PM_{2.5} SIP

Appendix M

ALLEGHENY COUNTY HEALTH DEPARTMENT

SUMMARY OF PUBLIC COMMENTS AND DEPARTMENT RESPONSES ON THE PROPOSED STATE IMPLEMENTATION PLAN REVISION (NO. 90) FOR THE ALLEGHENY COUNTY, PA NONATTAINMENT AREA, 2012 PM_{2.5} NAAQS

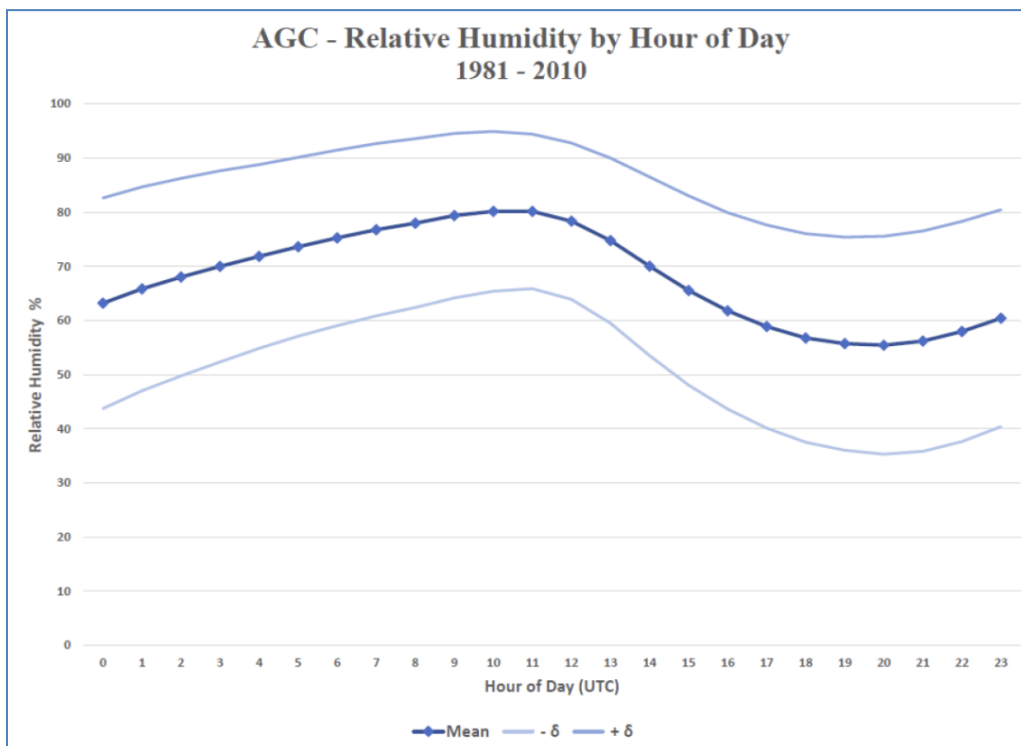
- 21. Comment:** ACHD's modeling for the future year 2021 is flawed because it is based on unrepresentative meteorological conditions in the base year 2011, where there was an unusually high amount of annual precipitation. Only four years of the past 30 years had a greater amount of precipitation, and only one of them occurred after the base year (in 2018). The base year also had the second-lowest number of annual inversions (157) during the 2009-2018 period, and year 2012 is far more representative of normal temperature inversion conditions than was the year 2011. Additionally, ACHD is implicitly appealing to climate change to substantiate its use of unrepresentative meteorological conditions for the future year, which is not recommended by EPA's modeling guidance.

Response: Based on the implementation rule, one of three years (2011, 2012, or 2013) was to be selected as the base year. As mentioned in Problem Statement (Section 2) of the SIP and the CAMx Model Protocol (Appendix F.2), part of the basis for selecting year 2011 was that 2011 NEI included the best-reviewed emissions data and modeling platform, and the use of other years would have required additional interpolations or estimations of emissions.

Wind and pollution roses show that 2011 represents the conditions during the five-year weighted monitored base period of interest – 2009 through 2013 – quite well. Although surface temperature and precipitation during 2011 were above normal and the frequency of inversions was below average for the period, temperature and precipitation during 2011 were closer to more recent weather conditions in Allegheny County.

As for morning surface inversions, on a monthly basis, October and November 2011 measured some of the strongest inversions of all months of the five years examined. In fact October 2011 recorded the strongest average inversion for any month during the five years under consideration. For 24-hour projections, only the highest (top 10%) days per quarter are used for the attainment tests, so the total number of high days in a quarter is less important than the highest overall days. Furthermore, in the county, based on the previous ten years of measurements, fall has the strongest inversions, while being the season with the second deepest, second most persistent, and second most-frequent occurrence of inversions of any season. And, historically, autumn months are typically when inversion conditions produce the highest particle-pollution concentrations. Thus, when looking more closely at the monthly data, 2011 represent worst-case, short-term conditions as well as variability for meteorology seen over the 2009-2013 timeframe.

Additionally, the modeled impacts are not used directly for the attainment tests, as the PM_{2.5} design value projection approach uses the base and future year modeled results in a relative fashion to scale the observed base year timeframe monitored values. Any modeled under- or over-prediction is carried over from base to future year. The modeling showed good model performance for year 2011, and it's expected that 2012 or 2013 would show similar performance. Specific meteorological conditions are less critical for the demonstration than the model responses under the tested conditions.

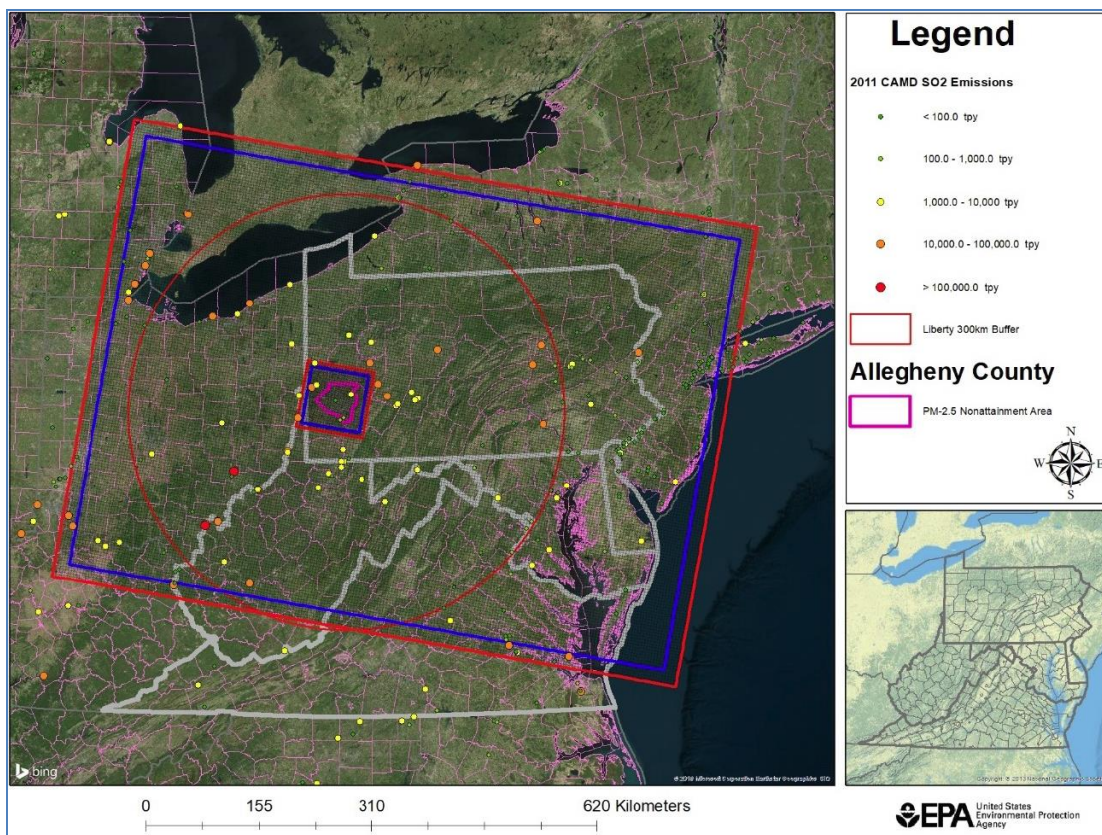
29. Comment: ACHD's use of a Local Area Analysis approach for the Liberty monitor is not consistent with EPA's procedures in the guidance document for attainment demonstrations for fine particulates. The purpose of a local area analysis is to supplement the results of the attainment test, not to replace the results. EPA recognizes that the application of a chemical transport grid model on a regional or local scale is the best tool available to judge the impacts of changes in future year emissions on concentrations (see Section 6.1.1 of the guidance). The CAMx model as configured for the SIP addressed local impacts by using the Plume-in-Grid (PiG) option, and ACHD's stated rationales for displacing the CAMx modeling are not justification for abandoning the CAMx results.

However, the most important factor concerns the modeled species apportionment with the CAMx modeling and MATS projections. As shown in the modeling documentation (see specifically Figure 2-6 in Appendix I.1), a large portion of the modeled excess was “other” component, which represents unspiciated primary PM_{2.5} that is not assigned to specific chemical compounds by the model. From the EPA methodology, and as built into the MATS software, other component is directly associated with monitored crustal component (or fine soil), calculated from concentrations of soil-related trace elements. However, the monitored excess species at Liberty are mostly carbons (see Appendix C) and not crustal component (or trace elements that might be lumped in with fine soil, such as iron). While the CAMx/PiG results are showing good overall performance for total PM_{2.5}, the model species mapping algorithms are assigning the incorrect species to the primary excess at Liberty.

Therefore, the modeled excess must be reassigned in order to correctly predict the Liberty concentrations. This is crucial to the future projections because a control that reduces primary PM_{2.5} emissions in the area will mostly scale down only the monitored crustal component when using the MATS software. This has little effect on the future design value, as crustal component is a very small portion of the monitored Liberty excess (see Figure 2.3 in Appendix C). A reduction in primary PM_{2.5} from a contributing source should realistically scale down the more prominent excess species such as carbons.

For the LAA, the solution to the species apportionment problem was to model local primary material (LPM) as a separate species with AERMOD, added to the CAMx results without LPM. LPM is the sum of all excess species, since AERMOD does not include chemistry. (The use of LPM also eliminates further error in the composition of species, focusing instead on just the magnitude of the total localized primary impacts.) The AERMOD results were then used to scale down the analogous monitored LPM (sum of excess monitored species), with the CAMx non-LPM results used to scale the regional species. The modeled local excess from AERMOD showed very good agreement with monitored local excess in base year (see Appendix G.3).

In terms of a simple analogy, the CAMx/PiG results generated an excess of four apples at Liberty, but the actual monitored excess showed an excess of four oranges. The LAA accounted for the excess by modeling four generic “fruits.” Even if additional modeling was not performed with AERMOD, additional recalculations would have been necessary to the CAMx output, as the MATS software does not allow for reapportionment of species.

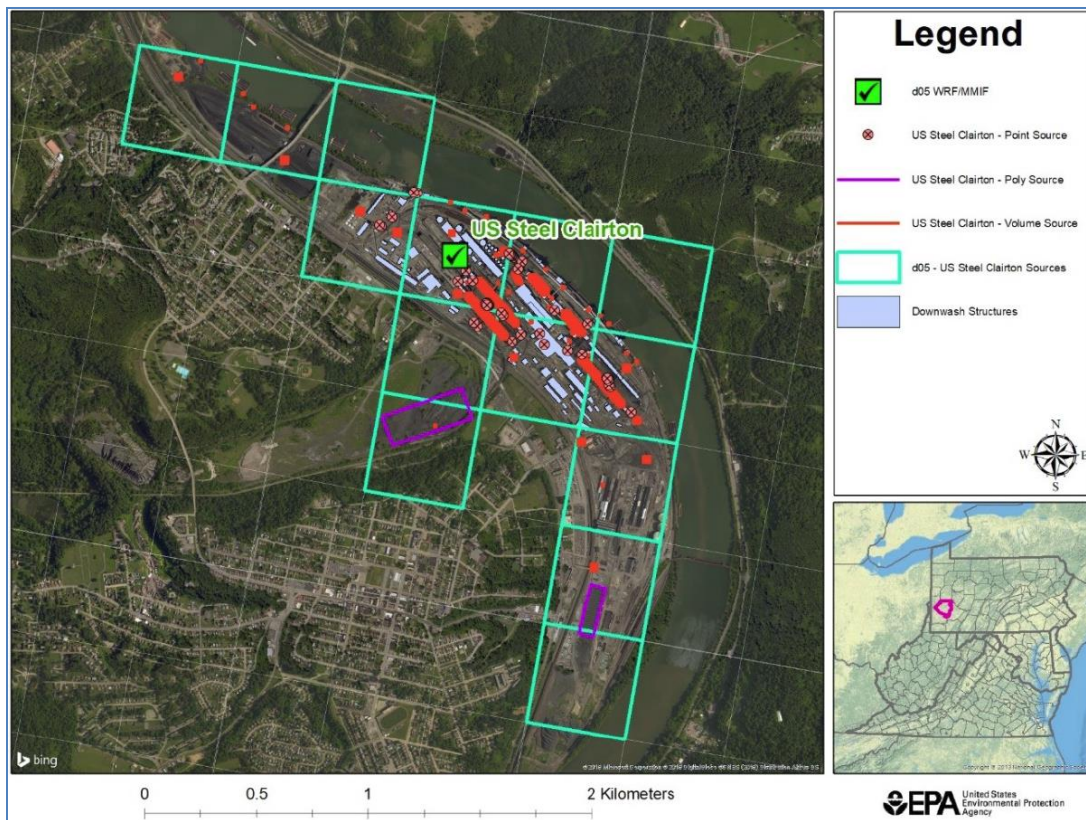
45. Comment: In Appendix I.1, Section 3.3.2. MATS Annual and 24-hr PM_{2.5} Projections in 4 km CAMx Domain: EPA compared the d03 (4 km CAMx) results from Table 3-8 to the 2017 PM_{2.5} design value spreadsheet available from EPA's Air Trends website. For the annual PM_{2.5} NAAQS, the d03 grid appears to be predicting higher future concentrations for most of the monitors within the domain (i.e. the 2017 monitor design values are already lower than the projected 2021 values). Similarly, for the 24-hour PM_{2.5} NAAQS, almost all projected values are higher than the 2017 monitor design values. This result seems to indicate the model may be over-predicting actual PM_{2.5} design values within the domain, making it more likely Allegheny County will attain the PM_{2.5} NAAQS by its statutory attainment date.

Response: ACHD acknowledges the findings. The overestimation is due mainly to the use of the ERTAC 2.4L2 emissions projections for SO₂ and NO_x from coal-fired power plants. The ERTAC 2.4L2 emissions for 2021 were essentially a 2015 inventory for power plants, with uncontrolled plants also adjusted for potential higher demand in 2021. Many deactivations and controls in place since 2015 and expected through 2021 have not been

accounted for in the modeled results. The regional modeled results can be considered to be conservative (overestimated) for actual future PM_{2.5} concentrations.
